660 University Avenue Mixed-Use Project

REVISED Final Environmental Impact Report/
Responses to Comments on the Draft EIR

SCH#2022110095

September 2025

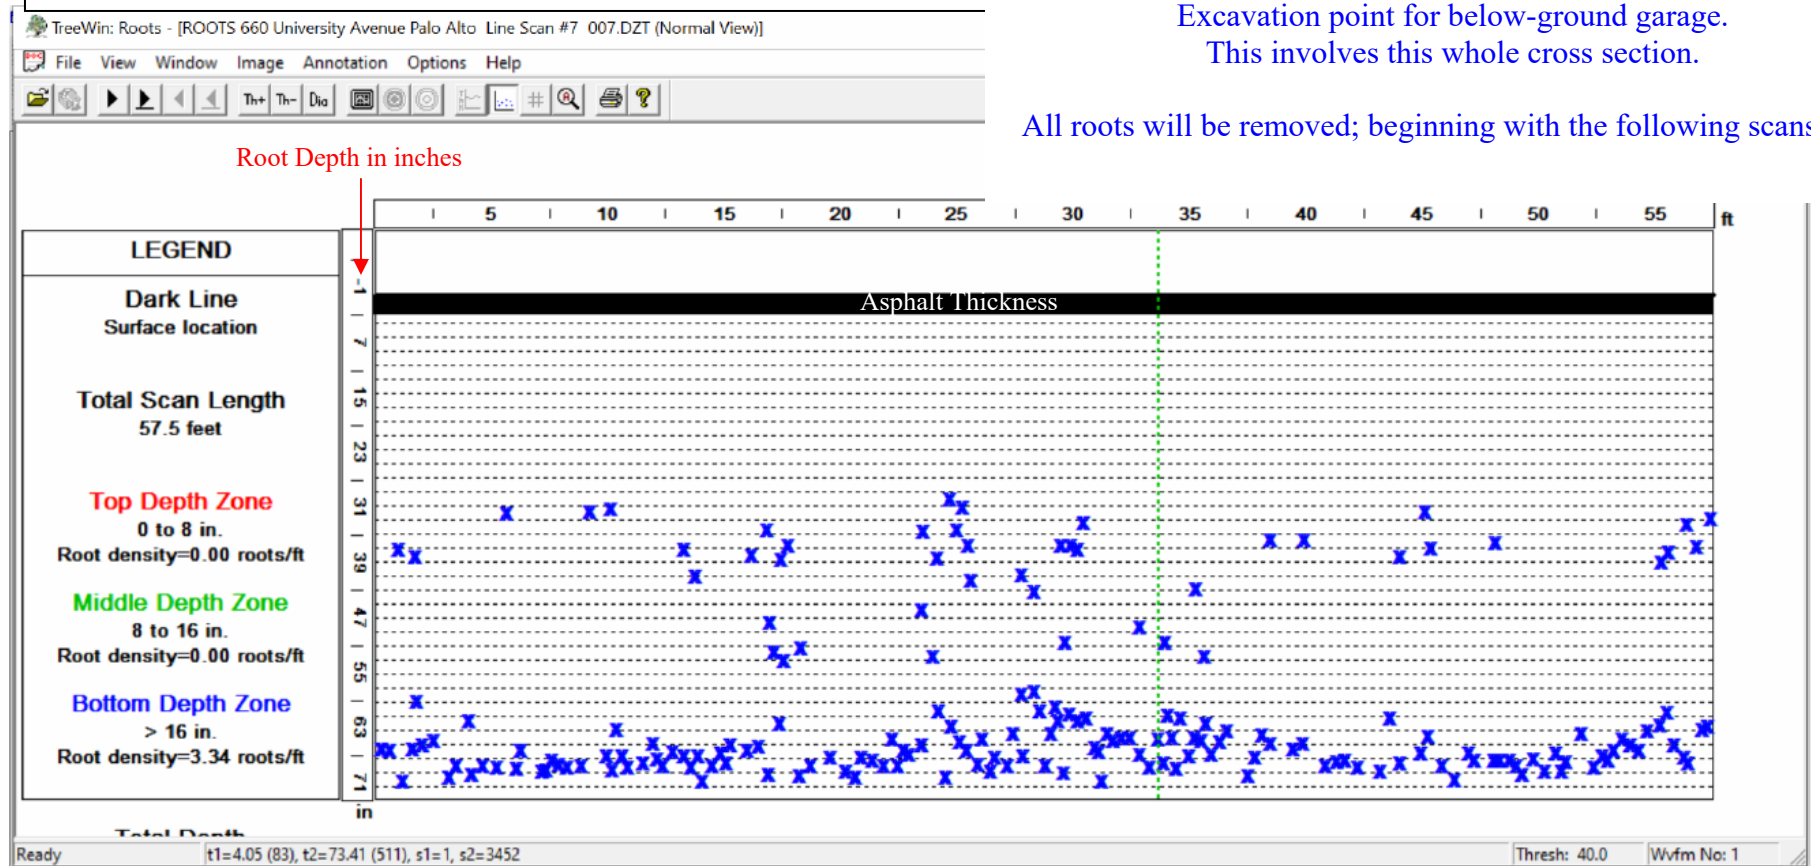
Excavation point for below-ground garage.
This involves this whole cross section.

All roots will be removed; beginning with the following scans 7-12

Sheet L1.1 (one page)

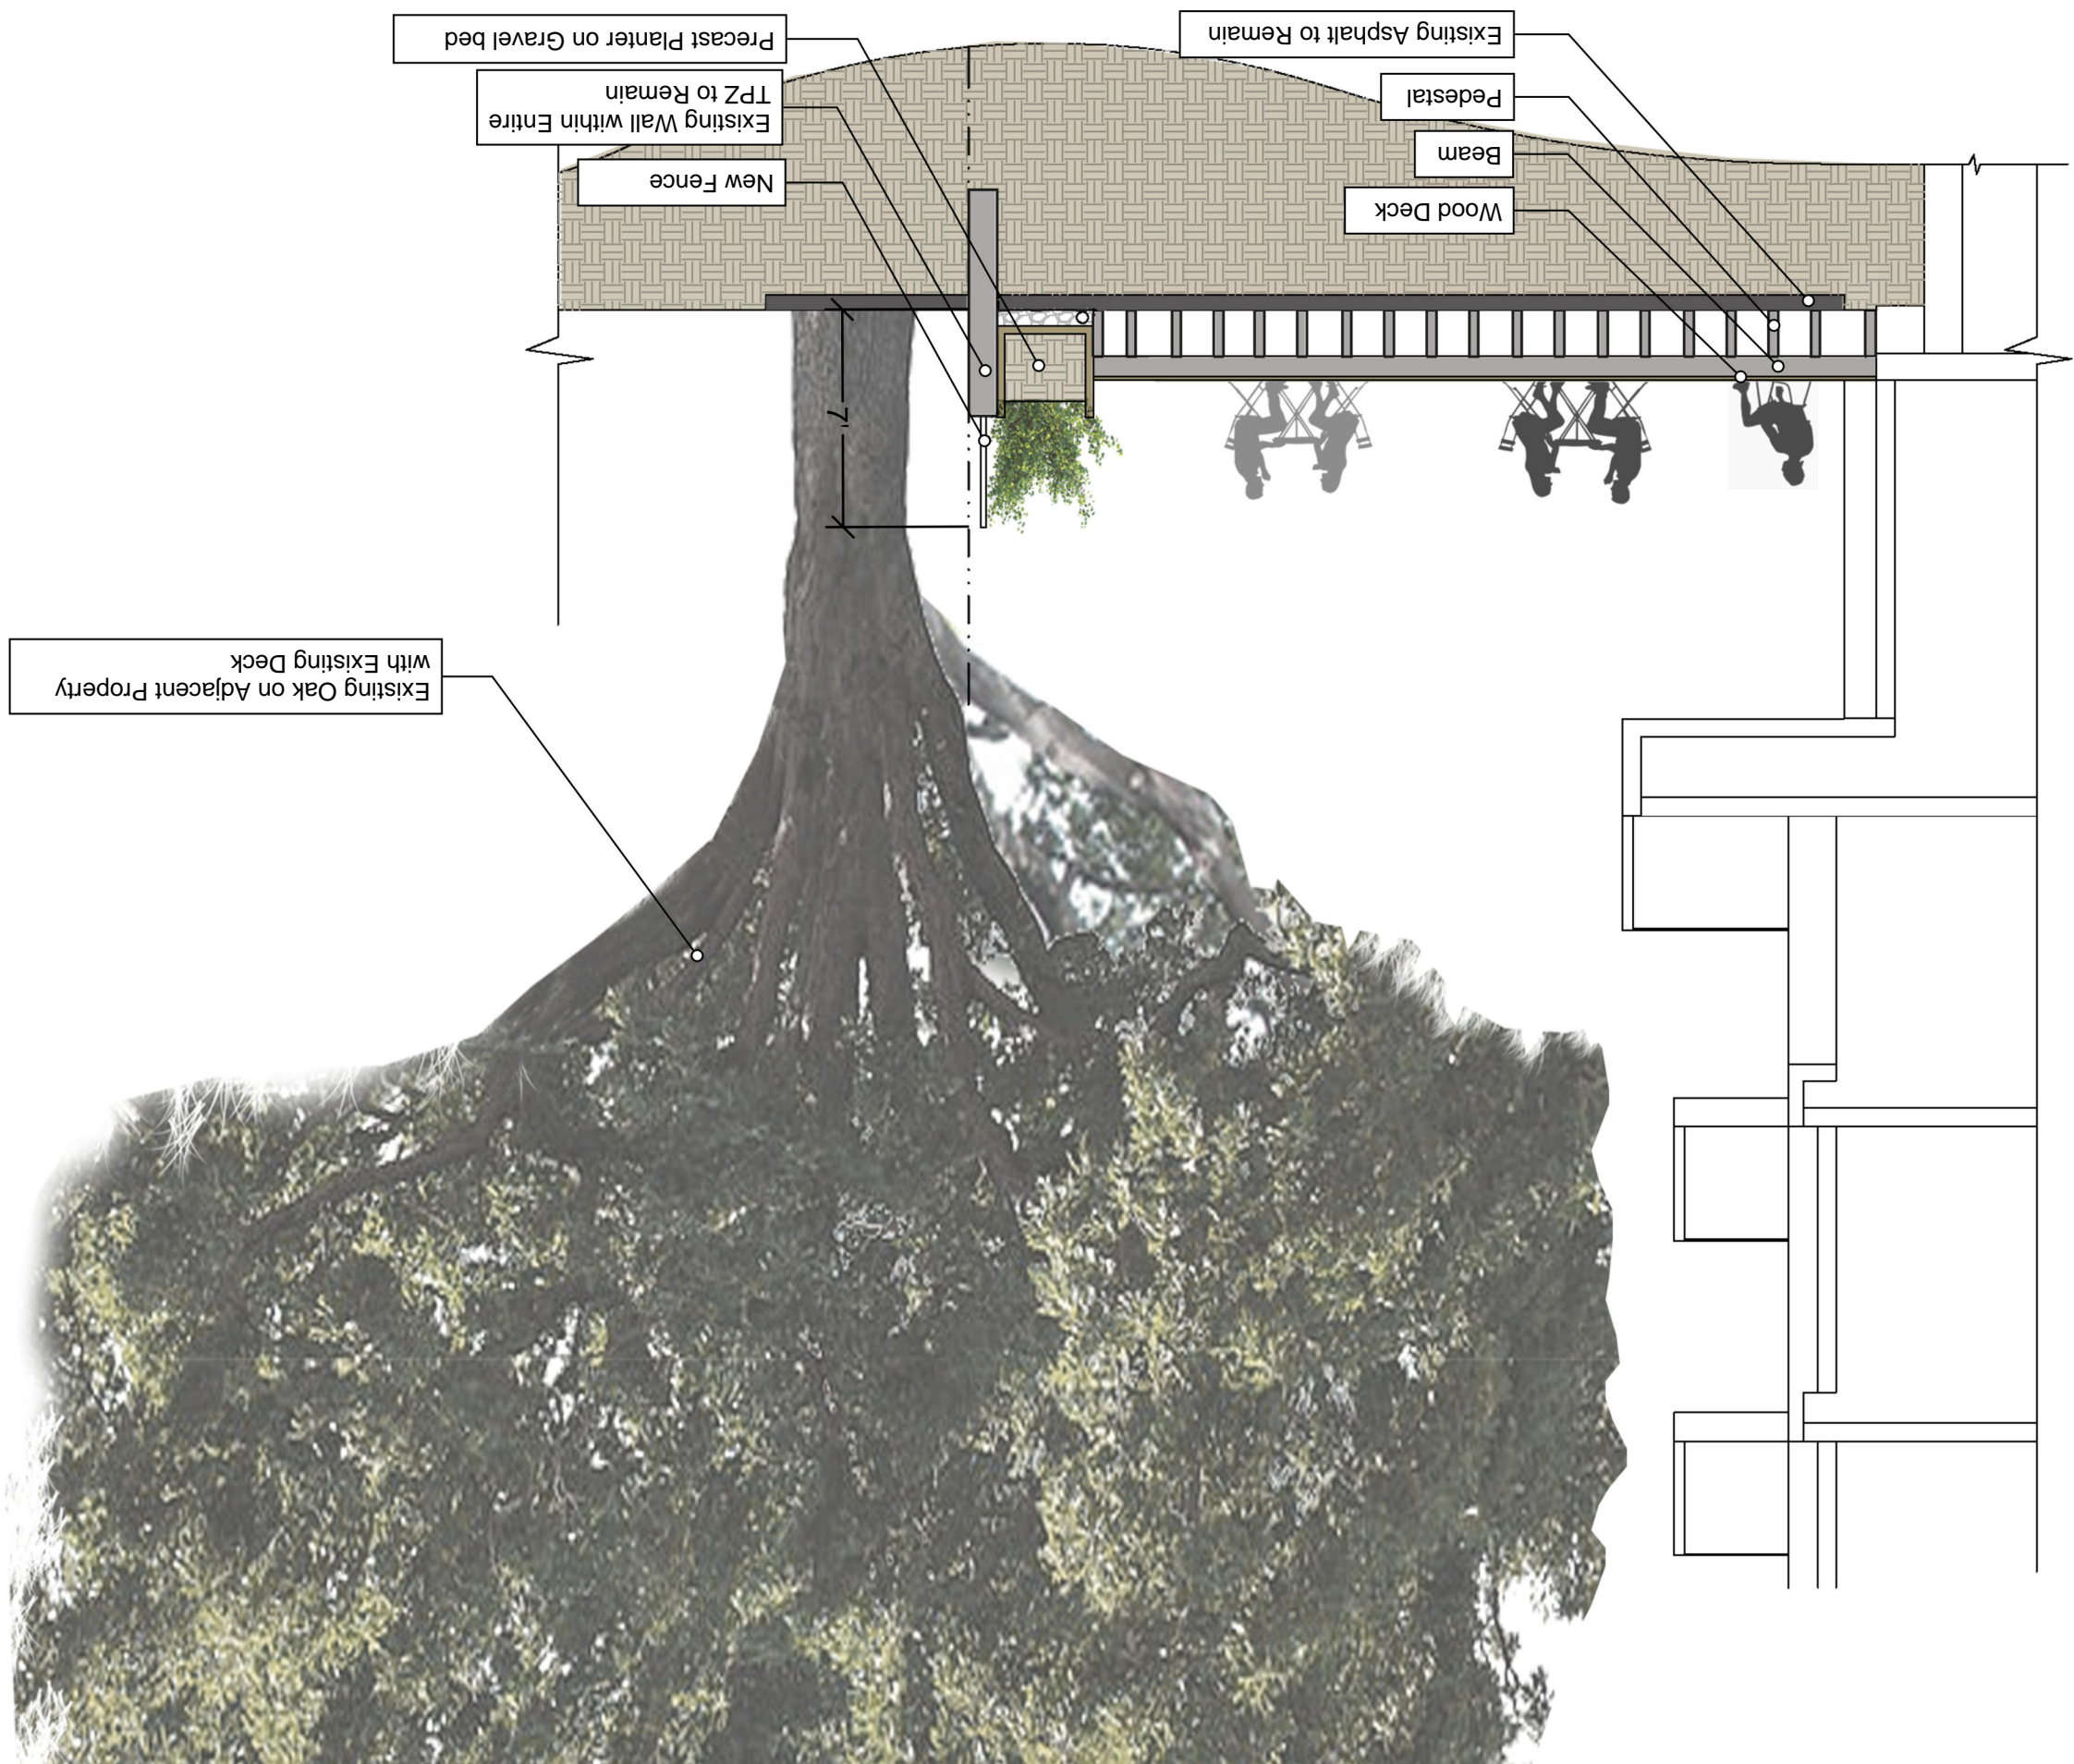
The 20-foot setback from #10's trunk for ground disturbance applies to any soil compaction, grading, subexcavation, overexcavation, trenching, drilling/auguring, storm drains, swales, etc. My review of proposed plans reveals this has been achieved, and a large section of existing asphalt within this area will be retained, a wood deck built on top, and section of existing retaining wall within the TPZ kept in place. Exhibit D includes both Sheet L1.1 and a detailed section of the proposed deck.

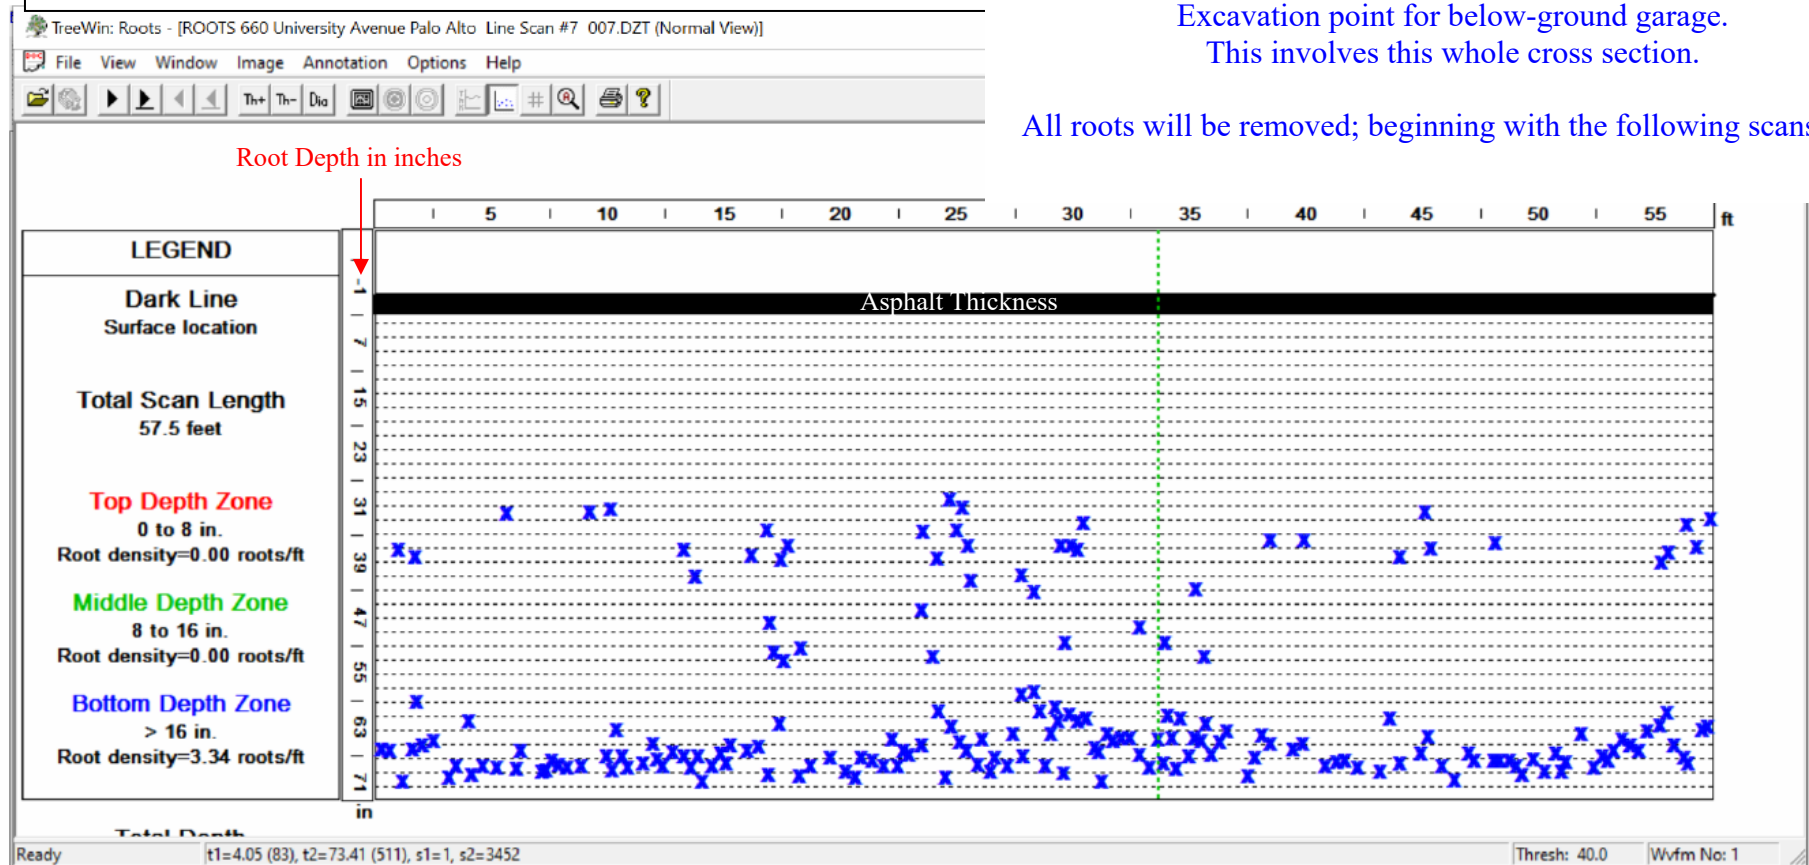
Excavation point for below-ground garage.
This involves this whole cross section.

All roots will be removed; beginning with the following scans 7-12
